SUMMARY OF NRC-DOE MEETING
ON TECTONICS
August 30-31, 1989
Rockville, Maryland

NRC CONCERNS REGARDING INTEGRATION OF DATA AND MODELS

NRC CONCERNS REGARDING INVESTIGATION OF POTENTIALLY ADVERSE CONDITIONS

VOLCANISM

Integration Concern #1: Shaft Location

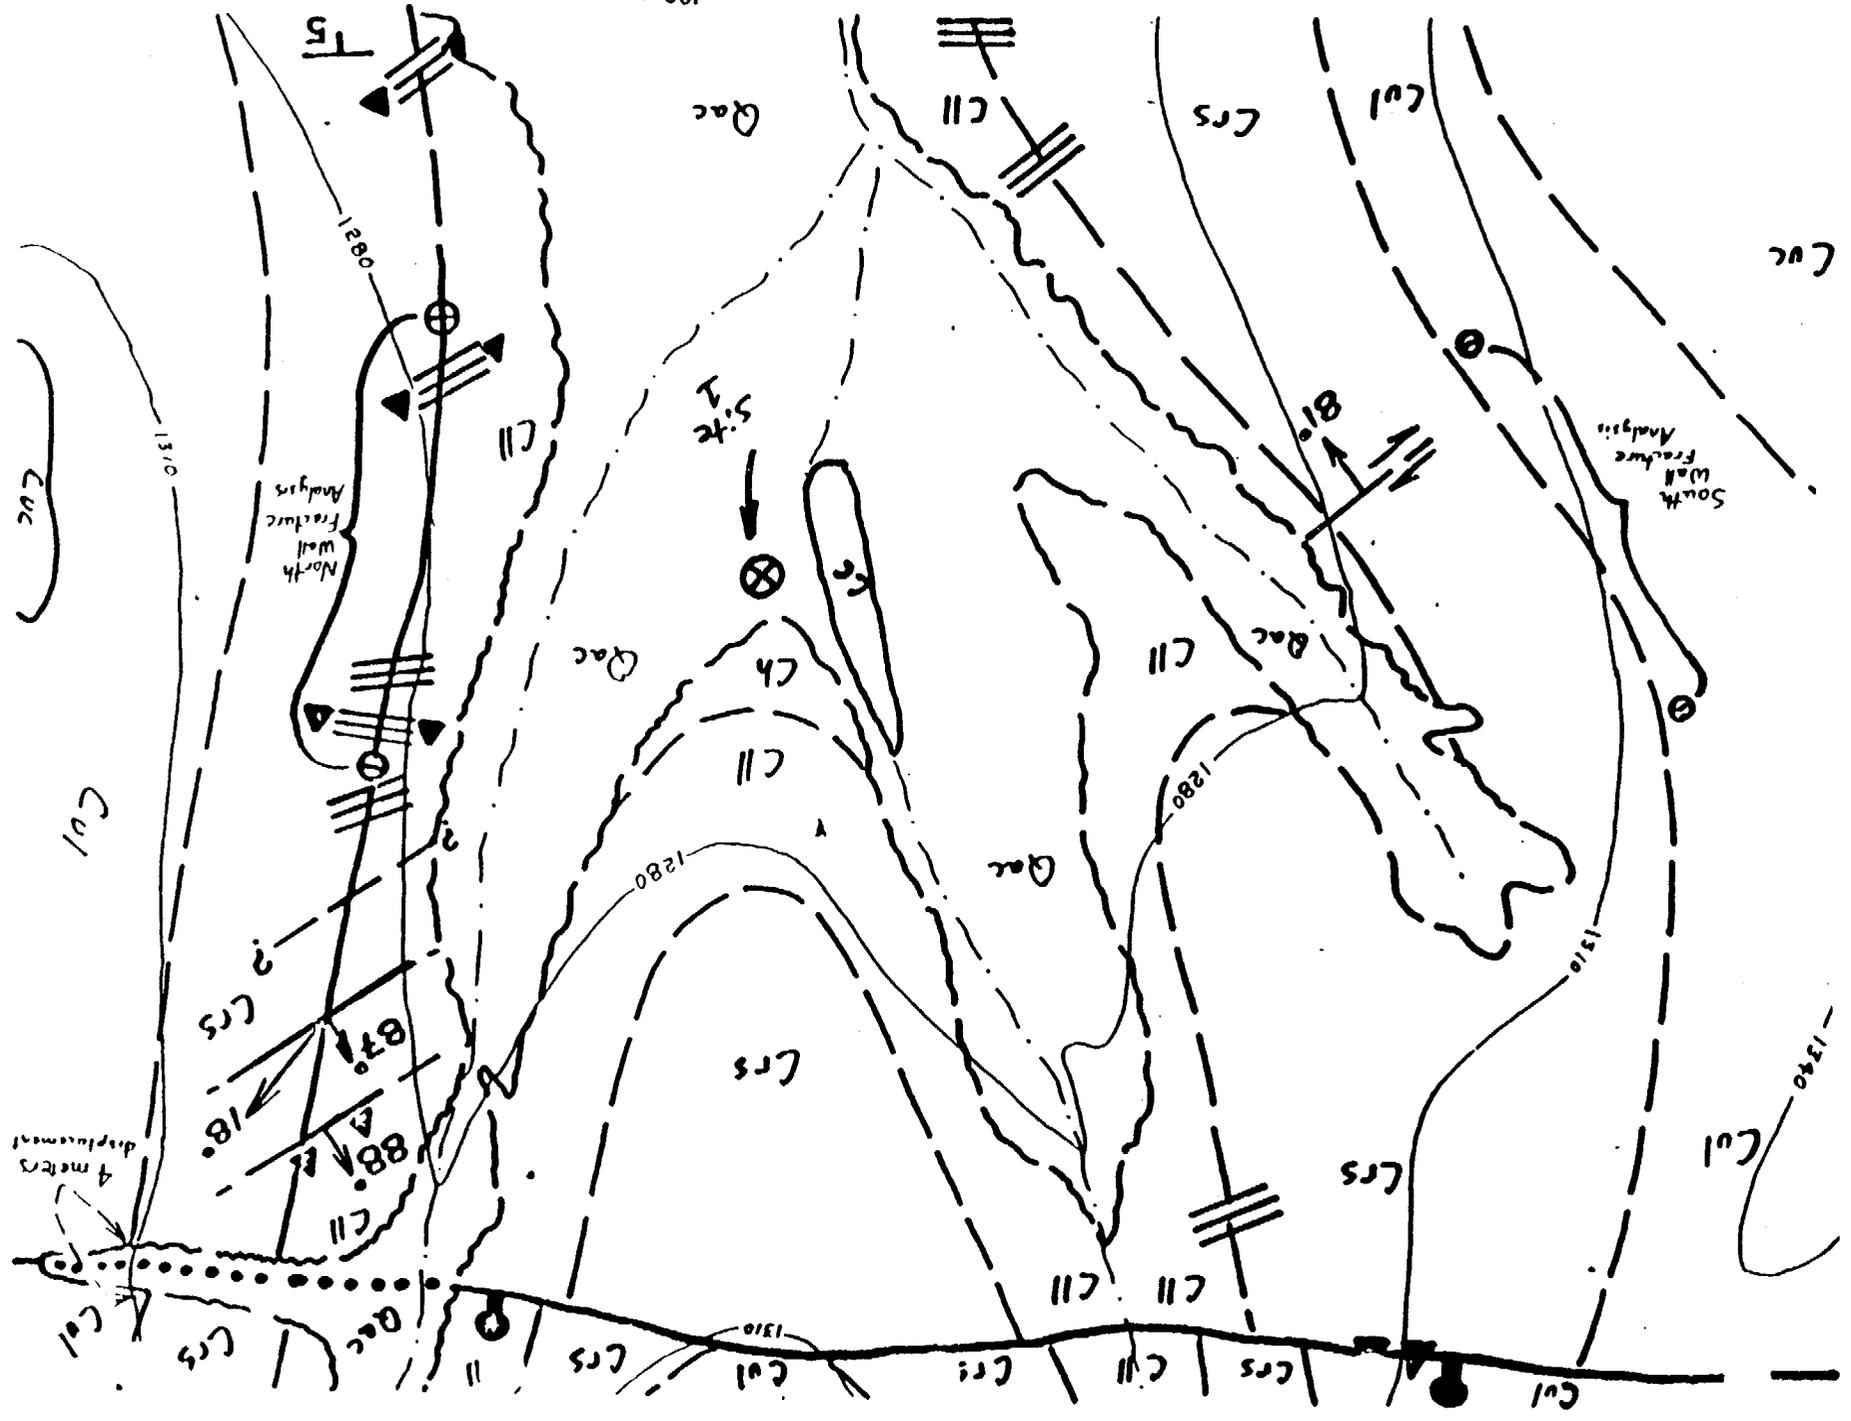
- Data presented in Smith and Ross (1982) suggest the possible presence of a fault in the vicinity of the ESF.
- DAA did not appear to consider the results of the geophysical testing (i.e., Smith and Ross) near the current location of the exploratory shafts in the assessment of performance.
- The DAA relied on the Bertram (1984) report to conclude that faulting is not a factor in shaft location. The Bertram report, however, did not include the results of activities recommended by the TIG to identify potentially adverse structures.

- Considering the new shaft locations, does the detailed mapping presented in the Dixon to Vieth letter cover a sufficient area to fulfill the recommendations of the TIG?
- What geophysical investigations were conducted in the vicinity of the new shaft locations to verify the presence or absence of potentially adverse structures?
- Considering the intensity of fracturing found in the vicinity of the shaft locations and the recommendation of the TIG that the sites be reevaluated if "joint densities are significantly higher at the recommended site," when was this reevaluation done and what were the results?
- Were the objectives of the TIG on shaft location met?
- What are the potential impacts on waste isolation of the possible presence of a major fault connecting the shafts with the waste emplacement areas?

- Reconsider whether the design process is adequate in light of the apparent failure to consider all relevant information.
- Address apparent conflicts between objectives for shaft siting and the possible presence of a fault in the vicinity of the shafts.
- Re-evaluate the potential impact on waste isolation of the present shaft locations based on an assessment of available data.
- Consider conducting further tests in the vicinity of the proposed shafts.

Figure 8.4.2-4. Conceptual repository layout in vicinity of the exploratory shaft facility dedicated test area and exploration drifts.

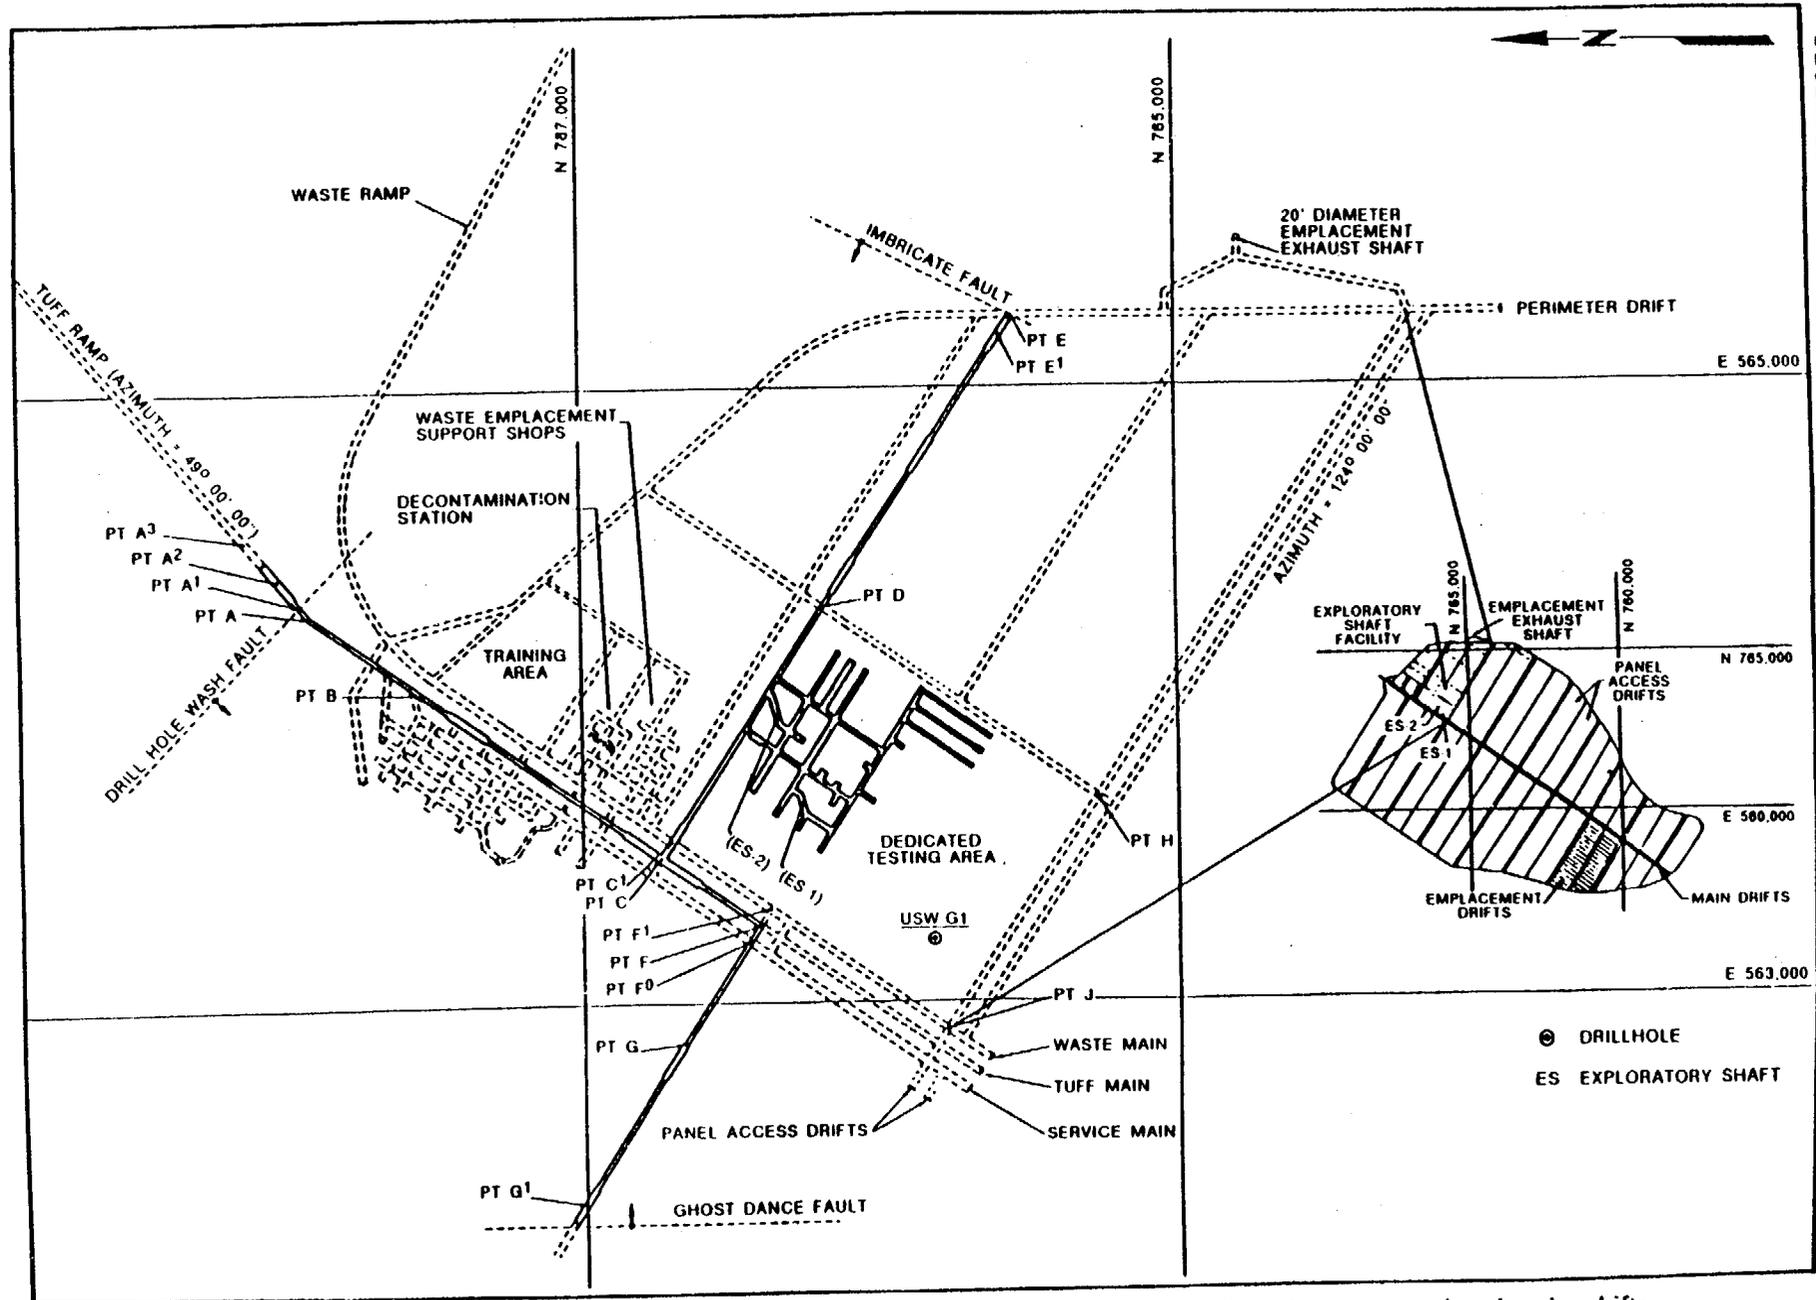
- Figures in the SCP (e.g., 8.4.2-4) suggest that the imbricate fault zone on the east extends well into the perimeter drift.
- Section 8.3.1.17.2.1.2 states that the program does not expect to encounter faults in the waste emplacement areas.
- The SCP implies that consideration is being given to emplacing waste in or near recognized fault zones.
- 60.133(h) requires that the engineered barriers be designed to assist the geologic setting in meeting the performance objectives. The presence of significant number of faults in waste emplacement areas suggests that this requirement may not be met.

- If the imbricate fault zone is present within the perimeter drift, an assessment should be made to demonstrate that the requirements of 60.133(h) will be met.

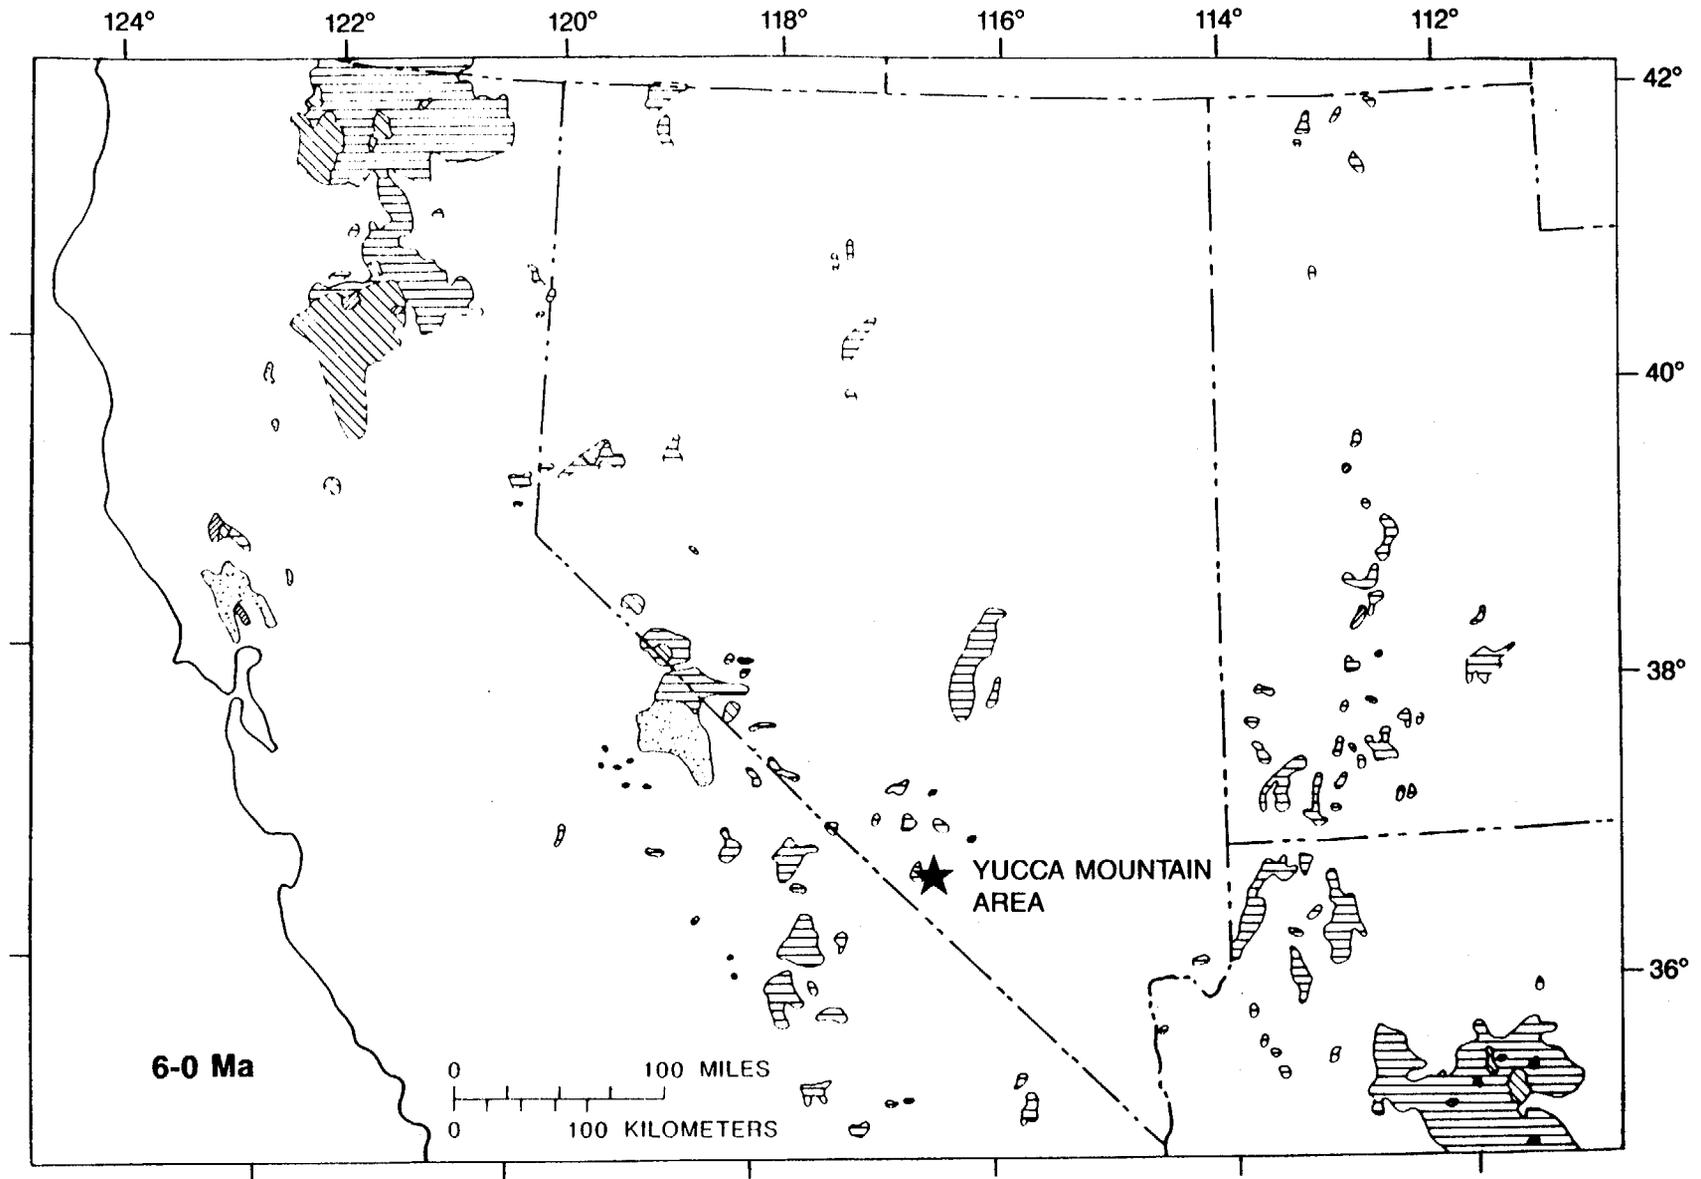
Note: Calculations based on circles and ellipses represented in previous figure assume tectonic model which requires equal probability of eruption at all locations within the chosen border.

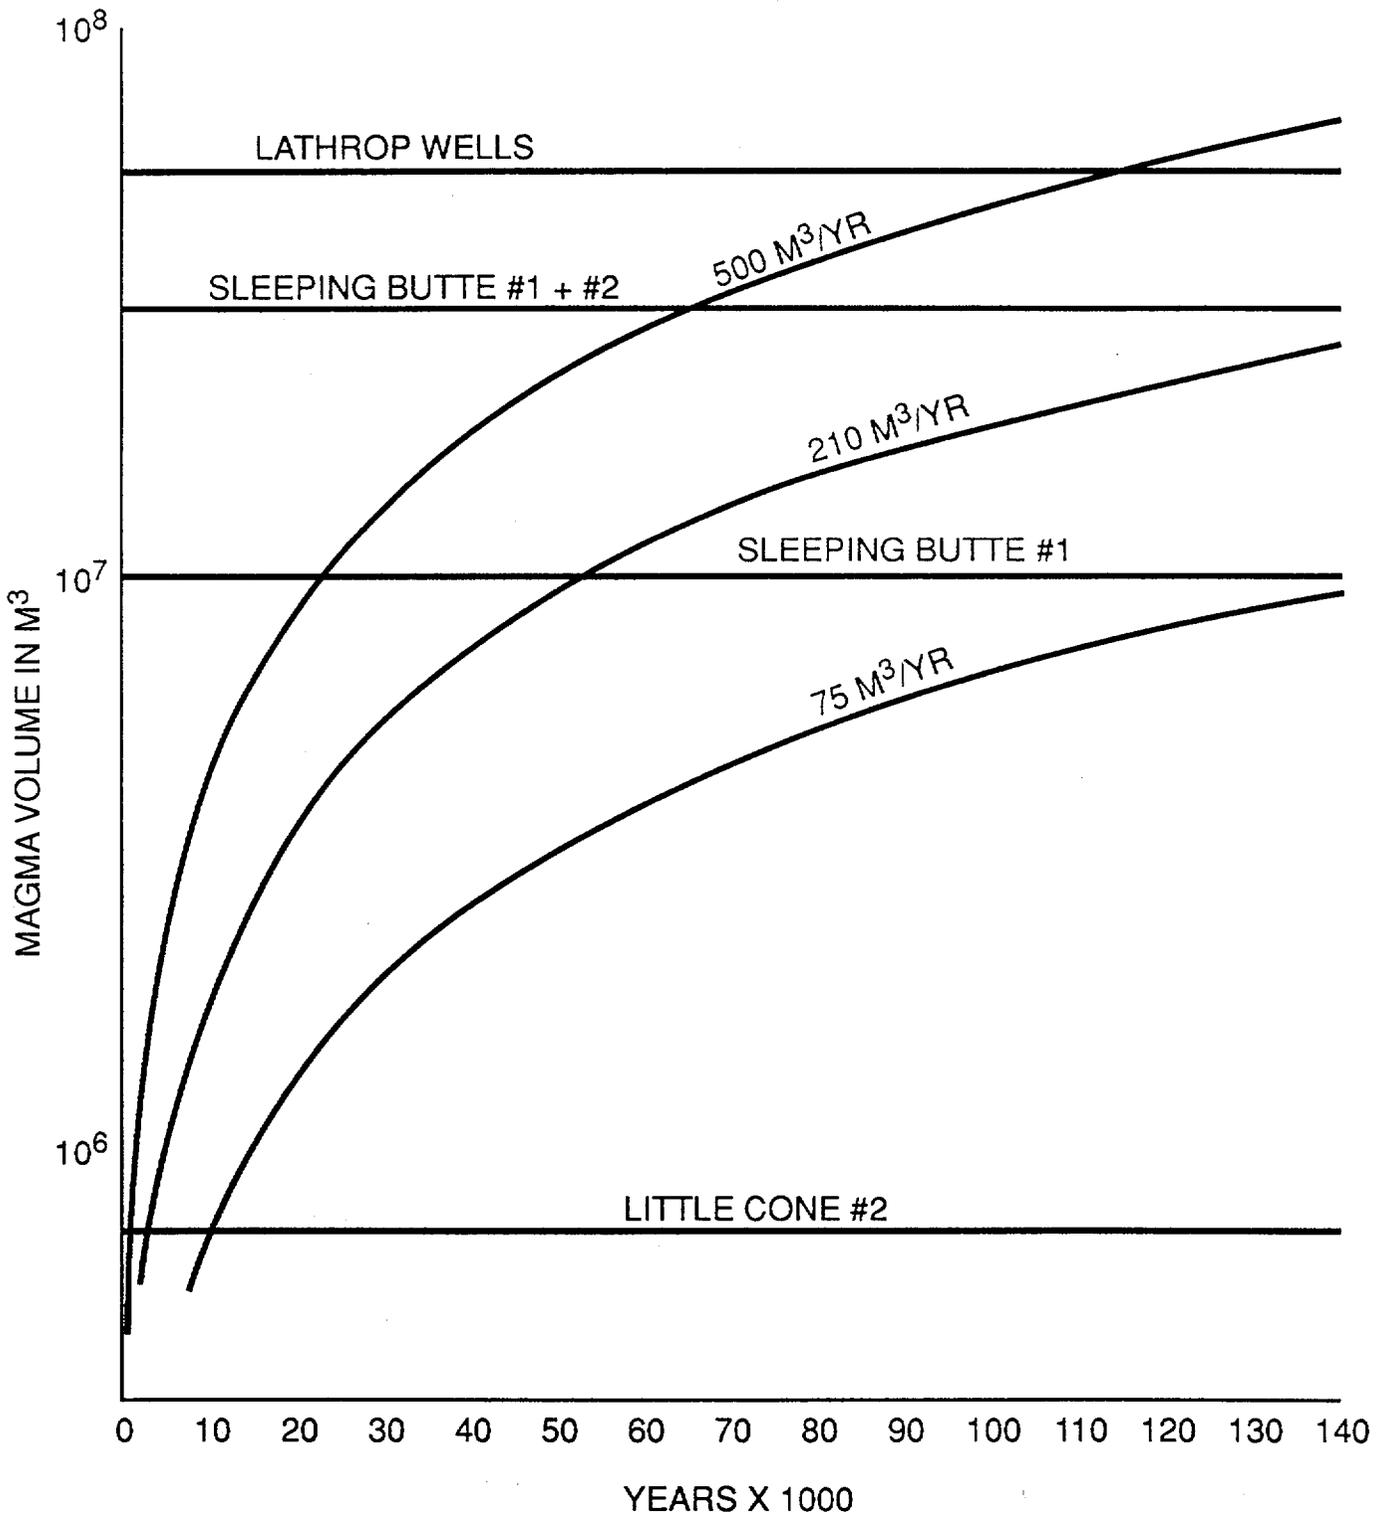
The “eruption rate” obtained from these data will differ dramatically depending on the time interval used and the way in which the events are distributed within that interval. Because volcanism is so episodic, both locally and globally, this problem will be encountered in almost every province and on every scale of measure. Unless one can define the temporal pattern of events and can say where we are in a cycle at a given time, the probabilistic calculations have little meaning.
